Response to Reviewer#1 TC-2022-123

Review of “Simulation of the current and future dynamics of permafrost near the northern limit of permafrost on the Qinghai–Tibet Plateau” By Zhao et al.

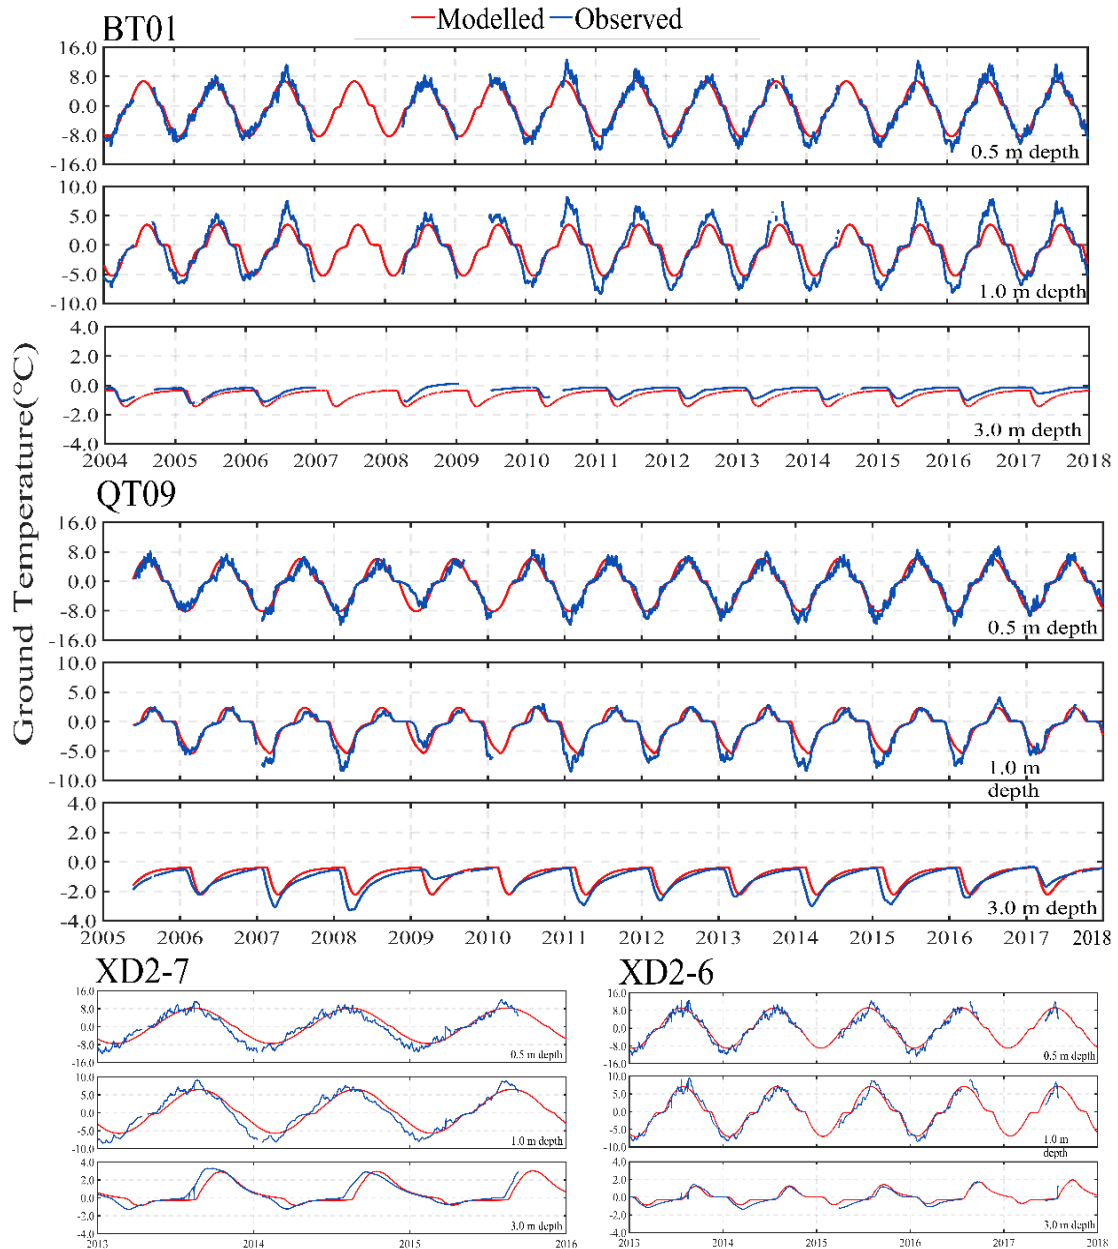
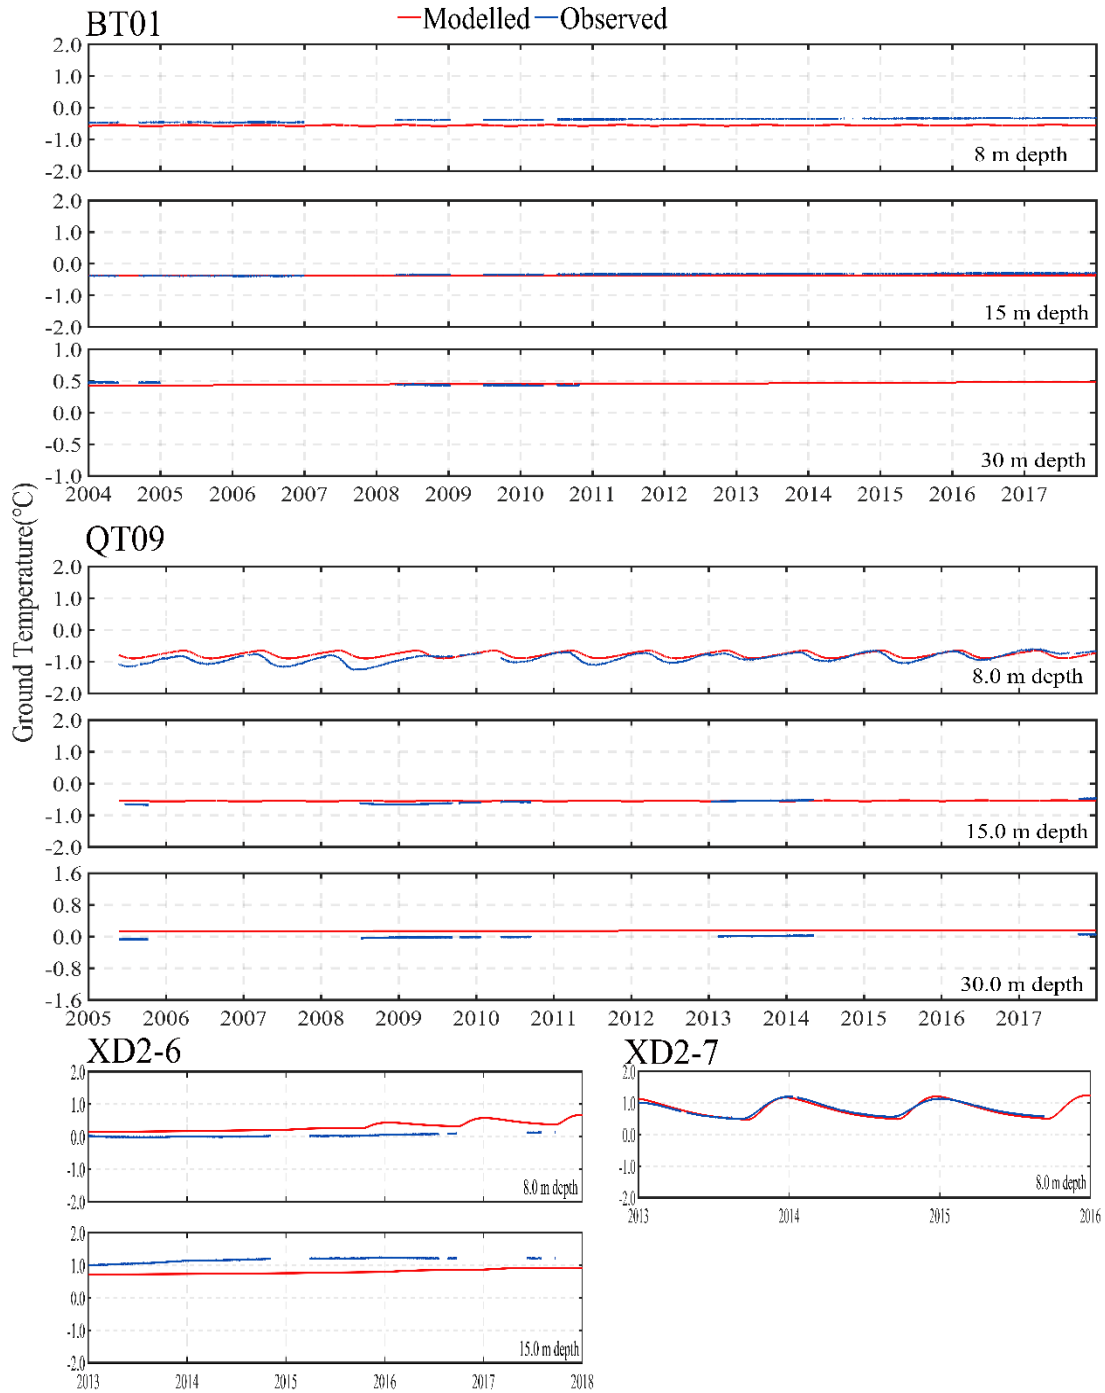
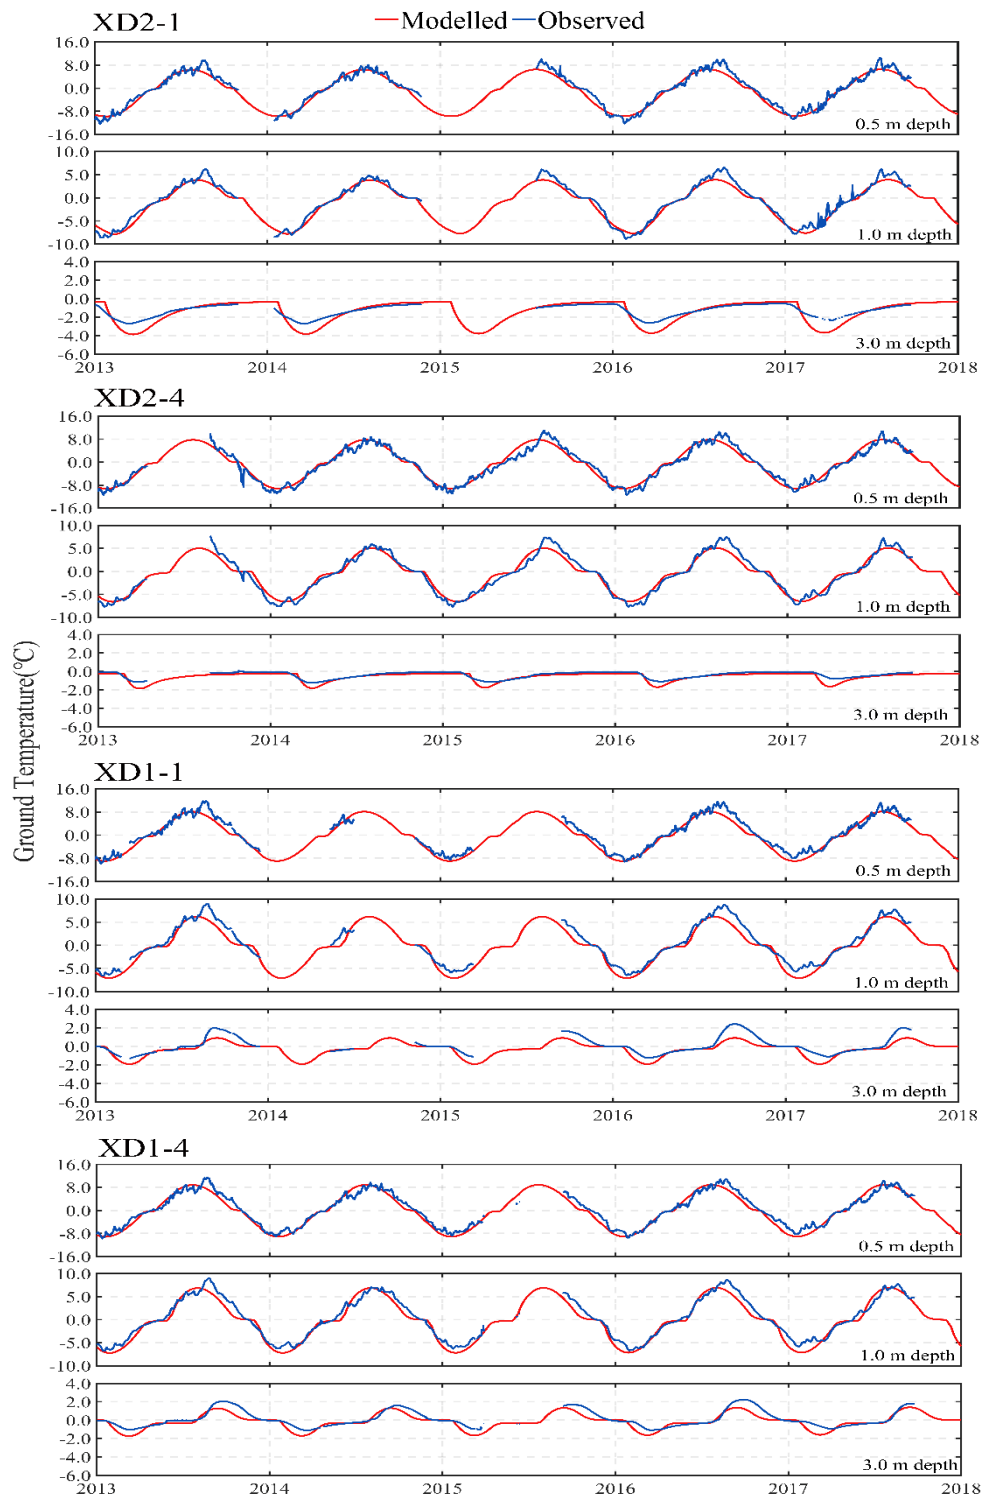
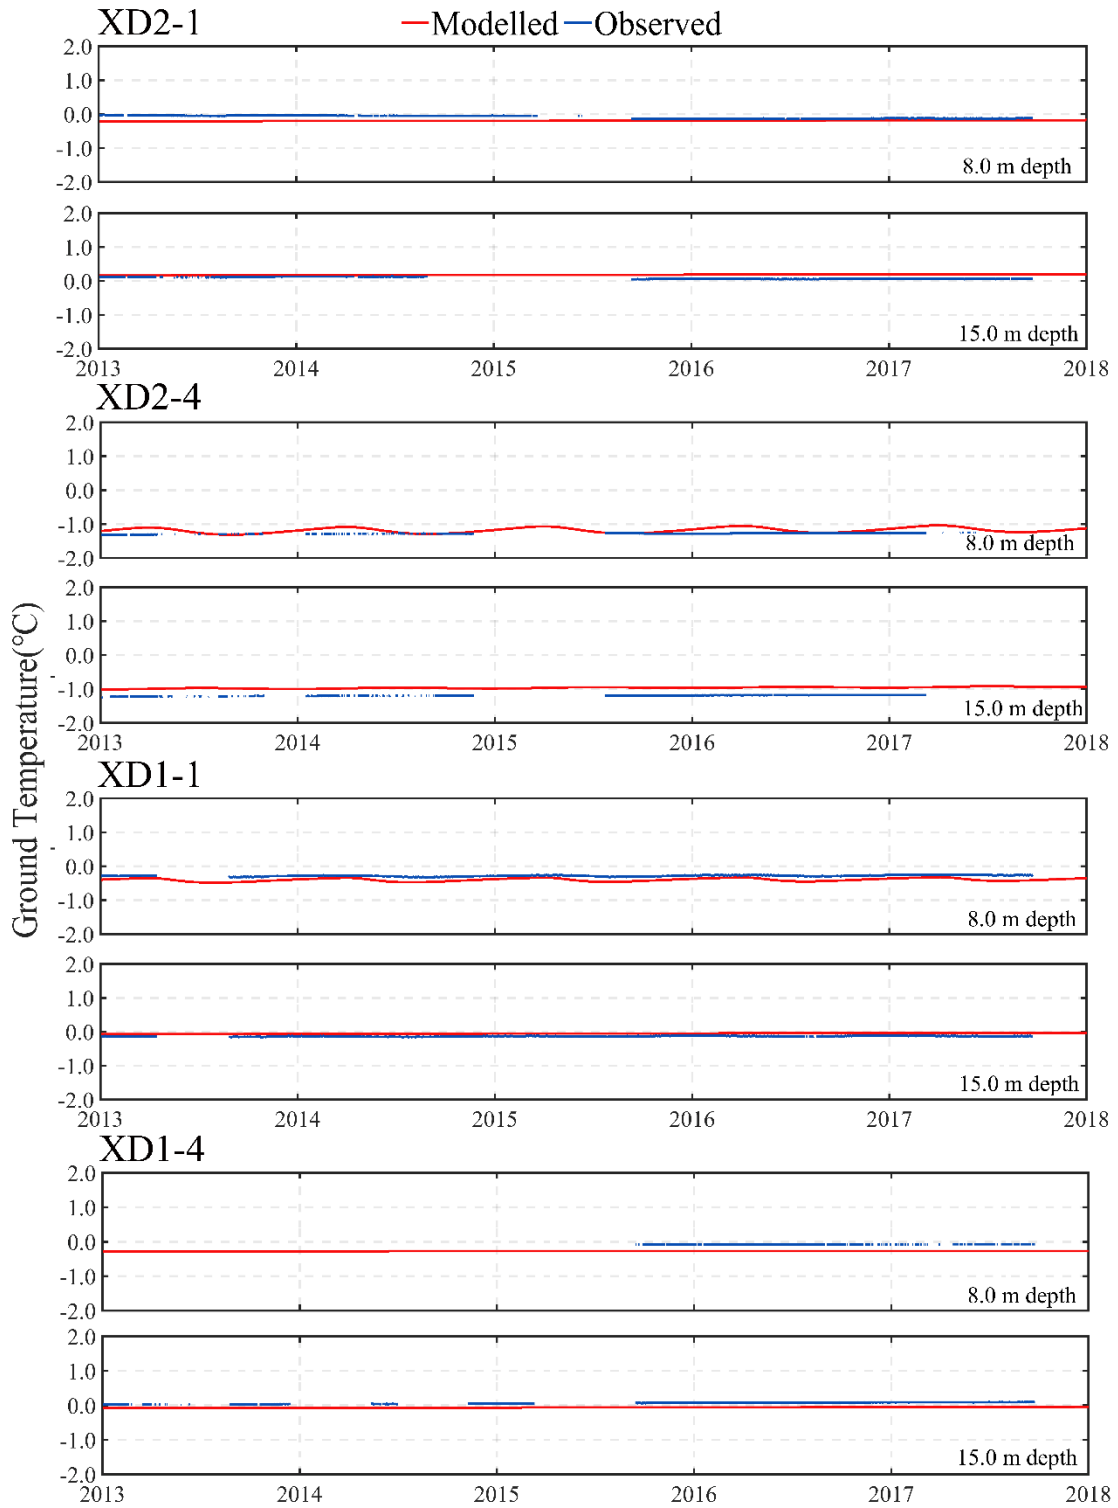
Fig. 2-5. I have several questions concerns about the results shown by these figures on model evaluation.

- How do you explain the better permafrost of model in reproducing the soil temperature in the shallow layers than that in the deep layers (8m and 15m) for some sties?

- Why in Fig.3 and 5, there are discontinuity of time series for modelled temperature while no discontinuity in observed results, which is against common sense.

- I recommend to use dotted line rather than dashed line for modeled time series since the dashed lines cannot clearly show the annual peak temperature.

This is just a special case in some areas, where complex surface conditions. The deviation between measured and simulated soil temperature in this special case might be caused by micro-scale heterogeneity in terms of surface cover, topography, and soil stratigraphy at the sub-grid scale. For example, XD2-6 has relatively poor performance compared with other sites. It may be attributed to being located at the edge of the island permafrost of river erosion area with high spatial heterogeneity of surface conditions (Luo et al., 2018; Yin et al., 2021). However, the deviation between the modelled results and measured values for this site within 0.38°C at the deep layer (15 m), superior to other models, such as LSMs. Furthermore, island permafrost was simulated to disappear in the mid-late 2010s, which was reasonable and in compliance with direct observation facts (Yin et al., 2021). We can conclude that various depths of ground temperature simulated by our model are still satisfactory for this site. On the other hand, the coordinate range of the graph is not adjusted well so that some sites seem to have a larger error in the deep layer. We have modified Fig. 2-5 in the revised manuscript.

We have made a supplement in the “3.1 model’s performance evaluation” section in our revised manuscript, the text there reads as “*Site XD2–6 has relatively poor performance compared with other sites, it might be caused by micro-scale heterogeneity in terms of surface cover, topography, and soil stratigraphy at the sub-grid scale, leading to more difficulty in accurate modeling.*”

We reversed the legend of simulation and observation, sorry for the mistake, and we have corrected the mistake in new figures.

Fig. 2-5 have been modified to make the contrast clearer.

Figure 6. Geographic distribution of permafrost and seasonally frozen ground across the Xidatan for three permafrost maps accomplished in 1975, 2012, and 2016 (left panels 1975 (a), 2012 (b),

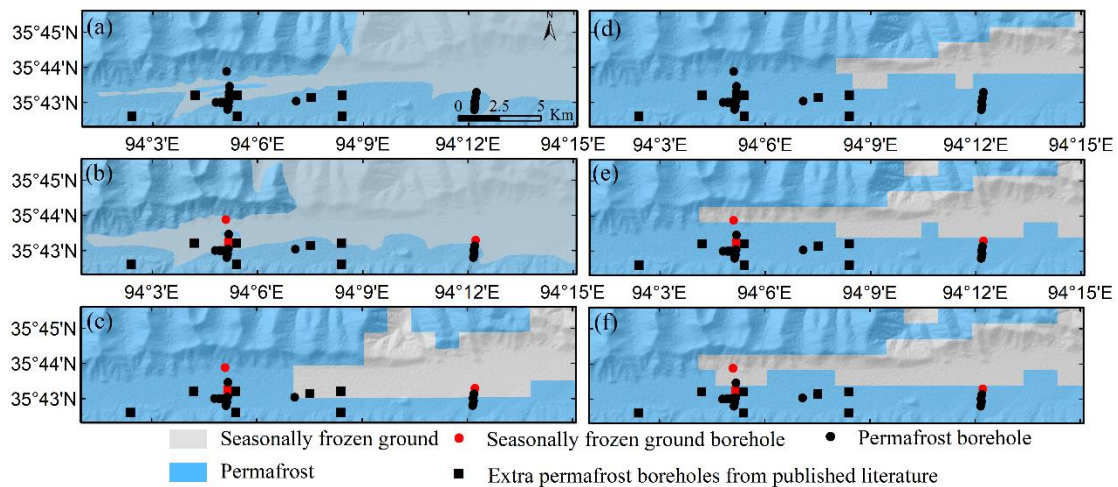
Fig.6, 8, 9, and 10. For these spatial patterns, some of them has white line for topography, while some do not. I recommend to add topography in all figures.

We have added topography in all figures in the revised manuscript. The details are as follows:
